**SAFETY  
RECALL**

**SR19-04A**

DATE :	June 2019	SECTION : 14 STEERING
SUBJECT:	<b>DRAG LINK REPLACEMENT</b>

Revision: A

Figure 1: Recalled draglink with turnbuckle and two clamps.

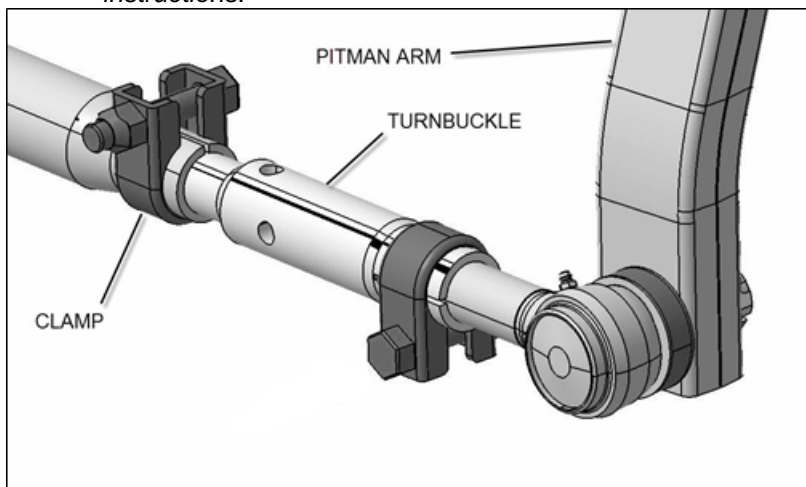
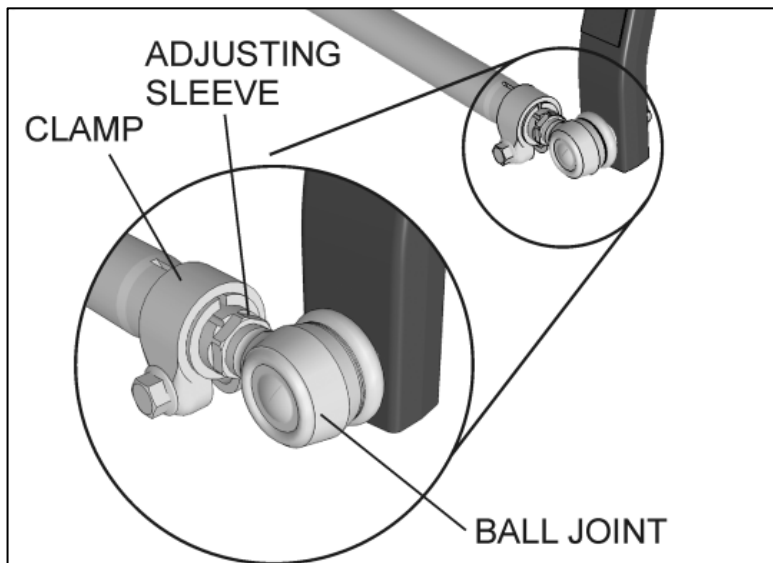
On the vehicles involved equipped with I-beam axles, cracks can occur and propagate in the steering draglink turnbuckle under certain conditions. If the cracks start to propagate, over time it may extend inward to a point where the turnbuckle may fracture.

If the turnbuckle fractures, a complete loss of steering would occur that can increase the risk of a vehicle crash or other risks associated with a disabled vehicle.

1. This recall involves a former draglink design with a turnbuckle near the pitman arm.(Figure 1)
2. Open the front service compartment and pull on the front bumper release. The pitman arm and steering draglink can be found on the driver's side.
3. The recalled draglink is identifiable by the presence of a *turnbuckle* and *two clamps* in the section nearest to the pitman arm. (Figure 1)
4. If it is confirmed your vehicle has the recalled draglink (Figure 1), you may proceed to the replacement.
5. If your vehicle does not have the recalled draglink design, please read further for *additional instructions*.

The improvement can be confirmed by the presence of an *adjusting sleeve* and a *single clamp* in the section nearest to the pitman arm. (Figure 2)

If the vehicle already has this draglink, this is the improved part being installed in the recall. *You do not have to perform the replacement.*

**FIGURE 3**

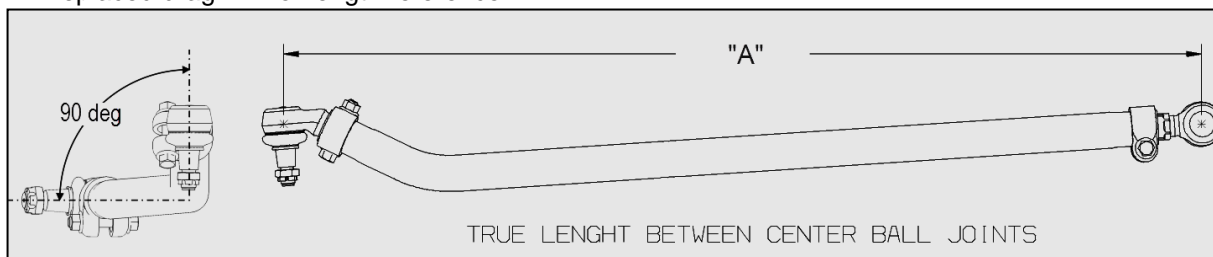
6. Check if the pre-adjusted length of the drag link is correct. To do so, try to install it between the steering arm and the pitman arm. If the length is not adequate, it must be adjusted to the required length. Use dimension "A" to adjust the length of the replacement drag link or you may use the replaced drag link for length reference.

Length A = 52" 3/8" ± 1/16" (1330mm ± 2mm)

**FIGURE 7: NOTE THE VERTICAL ORIENTATION OF THE CLAMP BOLT AT THE KNUCKLE END AND ON WHICH SIDE THE NUT MUST BE POSITIONED**

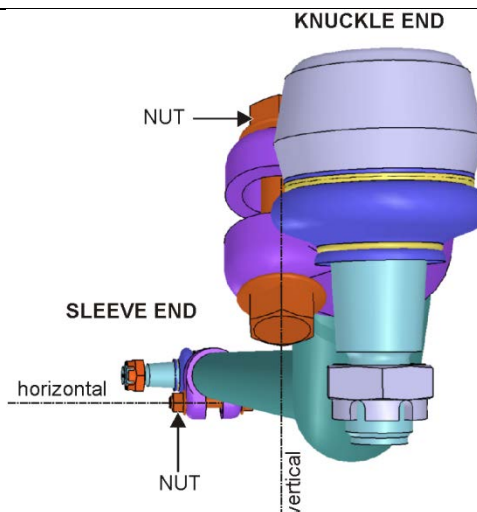
10. To prevent interference between the ball joint clamp bolts and other components of the steering system, the clamp bolt must be positioned vertically as shown on FIGURE 7. **Tighten the clamp nut to 118-133 lbf-ft.**

**Do not re-use clamp hardware.**

Bolt and nut should be replaced every time they are unscrewed. Use collar assembly 660018.

**FIGURE 10**

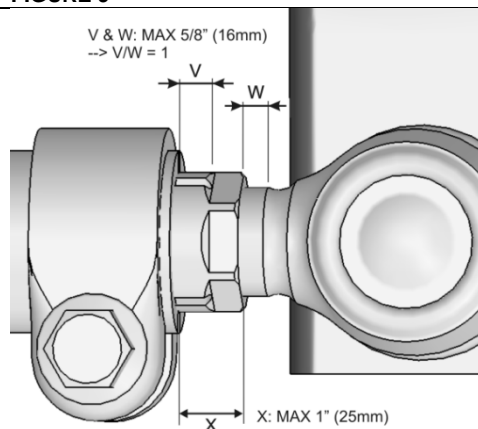
Do not exceed the following maximum thread lengths and values.

- Max dimension **V** : 5/8" (16mm) ± 1 thread pitch
- Max dimension **W** : 5/8" (16mm) ± 1 thread pitch
- Max dimension **X** : 1" (25mm)
- Dimension **V** and **W** should be equal. ( $V/W = 1$ )

**FIGURE 12: NOTE THE HORIZONTAL ORIENTATION OF THE CLAMP BOLT AT THE SLEEVE END AND ON WHICH SIDE THE NUT MUST BE POSITIONED**

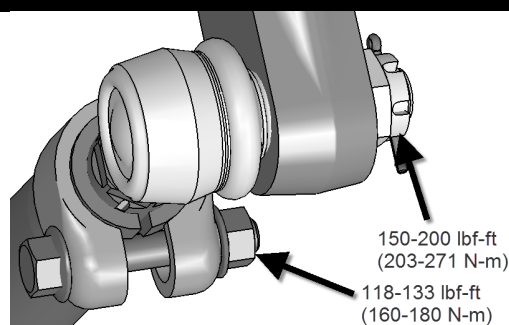
13. Adjust sleeve to the values of FIGURE 11.
14. Once the proper length adjustment is done, tighten the front end ball joint clamp. To prevent interference between the ball joint clamp bolts with other components of the steering system, the clamp bolt must be positioned horizontally as shown in FIGURE 12. **Tighten the clamp nut to 118-133 lbf-ft.**
15. Apply a torque seal mark
